Service Bulletin: SB 82

GAME: Theatre of Magic

SUBJECT: Ball hang-up near right side of trunk

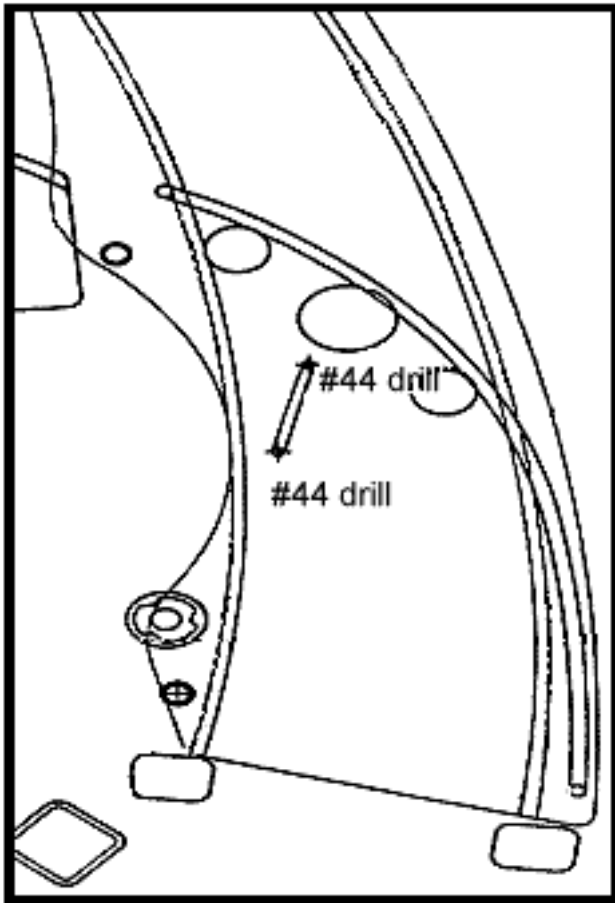
On **Theatre of Magic** a ball can come to rest between the right side of the trunk and the middle ramp. Ball search will move the trunk to let the ball roll out. Depending upon the speed of the ball and the angle that it enters this area, it is possible that the ball can lodge underneath the ramp.

On games manufactured after April 20th a 1" wire ball guide (part #12-6466-4) was installed to prevent this from happening.

If you have a game manufactured before April 20th and are experiencing this ball hang-up occurrence please install part #12-6466-4 using the instructions below.

A temporary fix is to put some foam tape (part #23-6534-3) underneath the ramp.

1. Lift lower ramp.
2. Punch wire location using as indicated.
3. Drill #44 pilot holes.
4. Tap in wireform to 1/2" height.
5. Re-install ramp.
